Review of Chief Adjudicator's report on signage associated with the John Dobson Street bus gate

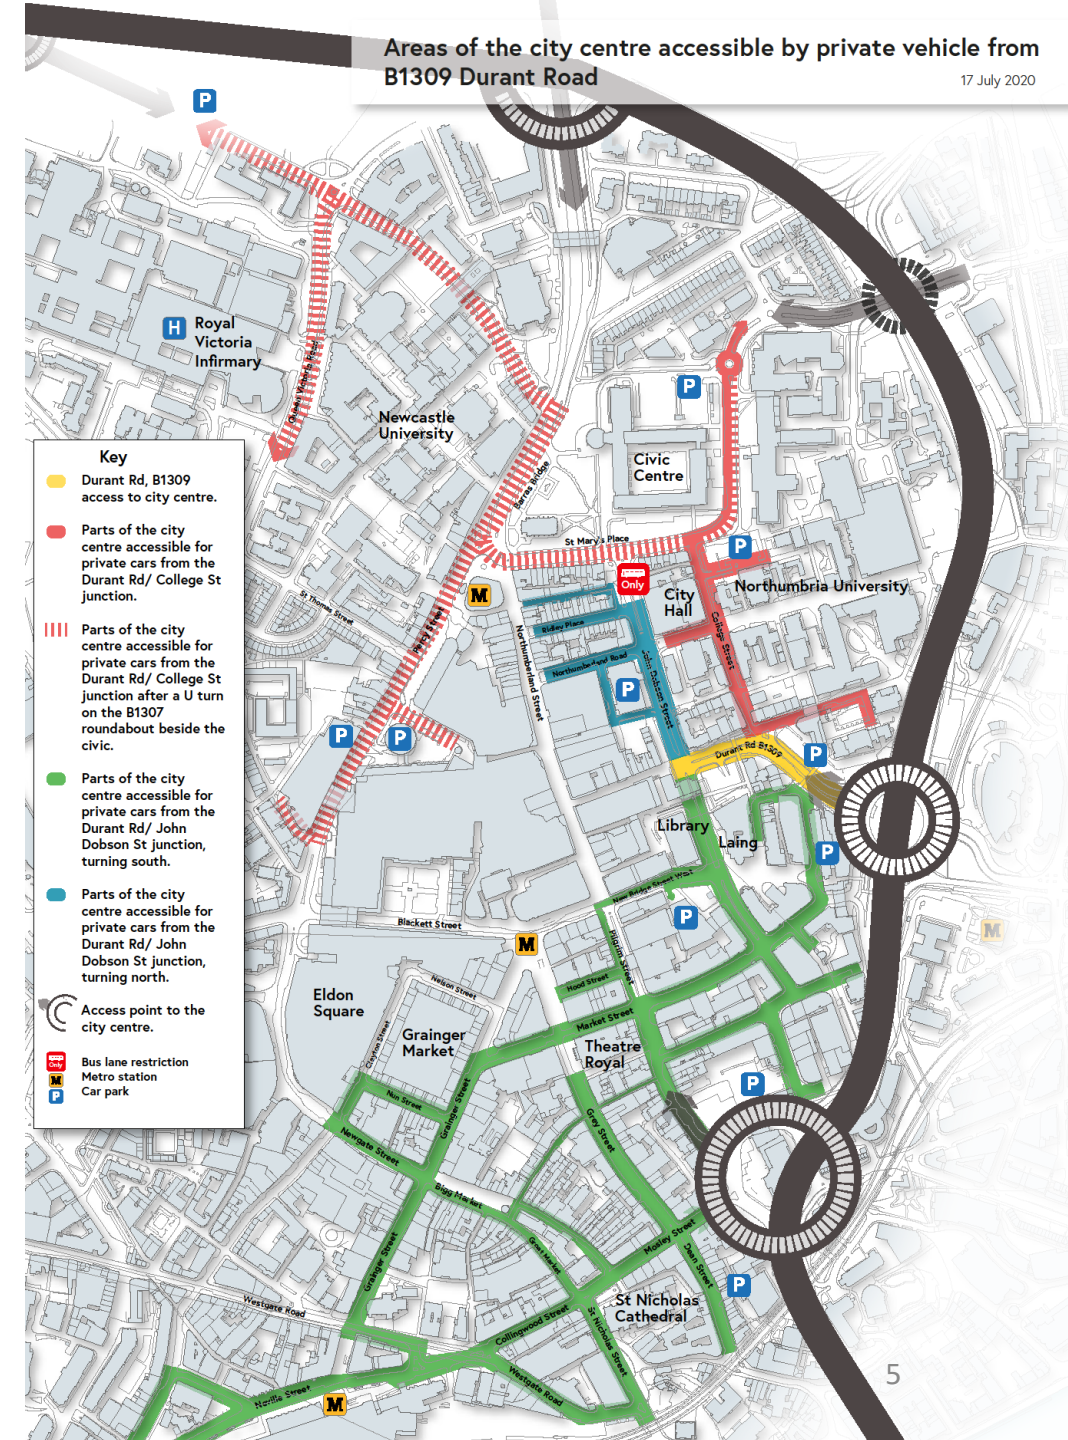
The CA asserts that the signage from the A167 “directs drivers to the city centre along the B1309, even though the city centre ceased to be accessible from the B1309 after the John Dobson Street bus gate restriction was put in place.” The CA also considers it “neglect” that such signage was retained.

This assertion is fundamentally incorrect, a significant proportion of the city centre remains accessible via the B1309 Durant Road (indicated in yellow) and John Dobson Street to the south of the Durant Road junction as shown in the image to the right.

All roads shaded green are accessible via John Dobson Street southbound (as opposed to leading “away” from the city centre).

Those shaded in blue are accessible from turning right onto John Dobson Street and heading northbound. Even those roads shaded red (or dotted red after another turning manoeuvre) are accessible via B1309 Durant Road and College Street.

It is therefore from a technical perspective clearly inaccurate to note that the city centre ceased to be accessible from the B1309 after the John Dobson Street bus gate restriction was put in place.

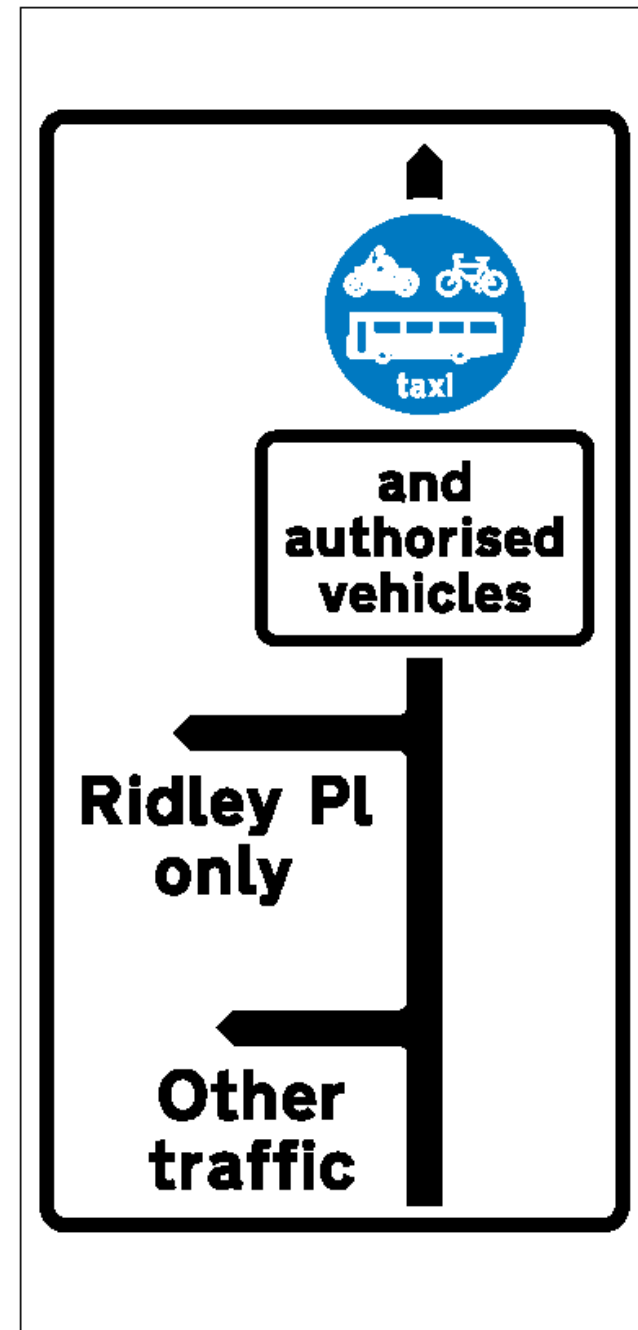
Once off the New Bridge Street junction and past the sign(s) indicating the B1309 City Centre, all advanced directional signs prior to the bus gate show all routes at 2.5 sw, indicating that these are all local urban roads that are not intended for through traffic, and certainly not indicating that a through route is available.

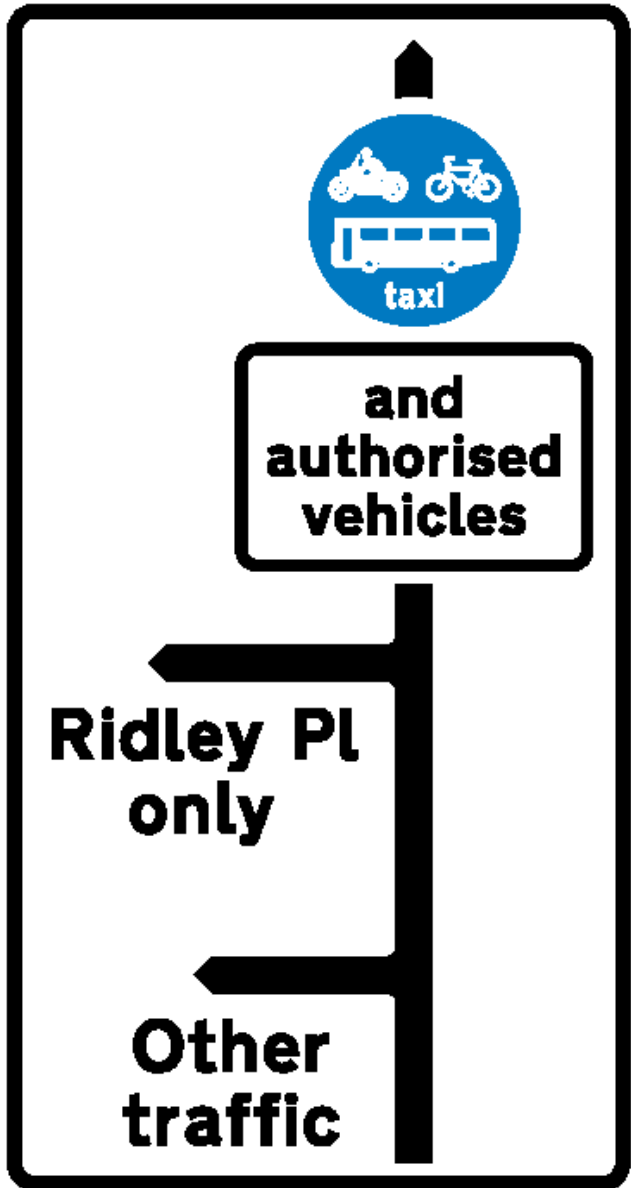
The CA says that this signage is *"misleading and wrong. Both the turnings to the left are shown by a line with chevron point at the end indicating a through road"* ...

“the Ridley Place turn should have the red “no through road” ending to the line. This is a fundamental error.”

TSRGD is clear that the red ‘no through road’ ending may only be used when there is no quoted destination on the sign.

The TSRGD allows one or the other, not both.

This revised sign, suggested by the CA, fails to convey to drivers the destination of each of the turns and also fails to communicate where traffic should go to avoid the bus gate restriction.
